UNITED STATES PATENT AND TRADEMARK OFFICE

10/570,803

Office Action Summary	Application No. 10/570,803	Applicant(s) YOON ET AL.	
	Examiner GERARD T. HIGGINS	Art Unit 1794

DETAILED ACTION

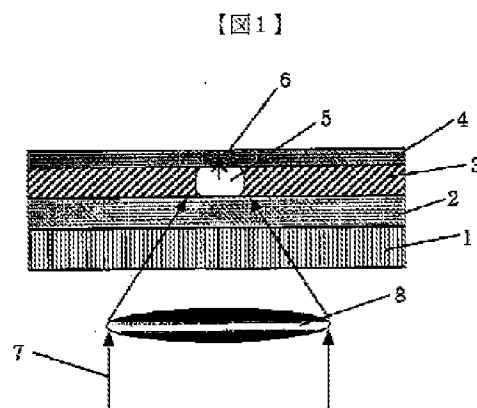
With regard to claim 1, Kuwabara et al. disclose a master optical disc [0002], which reads on applicants' recorded master, of the structure in Figure 1.

The device is comprised of a substrate **1**, which reads on applicants' master substrate, an optical absorption thermal-conversion layer **3**, which reads on applicants' heat absorption layer, a substrate protective layer **2**, which reads on applicants' dielectric layer on at least one of top and bottom surfaces of the heat absorption layer, and a

feeling-of-heat reactive material layer 4 [0011], which reads on applicants' separation layer. The heating of the optical absorption thermal-conversion layer will transfer that heat to the feeling-of-heat reactive material layer as is implied by their names and as seen in the Figure (arrow showing direction of heat).

FIG. 7

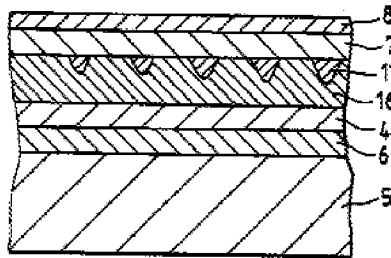
With regard to claim 1, Terao et al. disclose the device of Figure 7.

The optical medium of their invention may be considered a recorded master because the information contained within the recording layer may be reproduced and reused in the manufacture of an information storage medium (i.e. mp3 files). The device is comprised of a master substrate **8**, a heat absorption layer **16**, which is on the master substrate, and a separation layer **5** (col. 8, line 64 to col. 9, line 10 and col. 13, lines 17-36). The layer **16** has recorded data on the bumps or dents of the layer **16**, providing discrete data points.

With regard to claims 6 and 7, there may be top and bottom protection layers **7** and **4**, respectively, which are comprised of the a ZnS-SiO₂ dielectric mixture (col. 9, lines 2-5 and col. 13, lines 17-36).
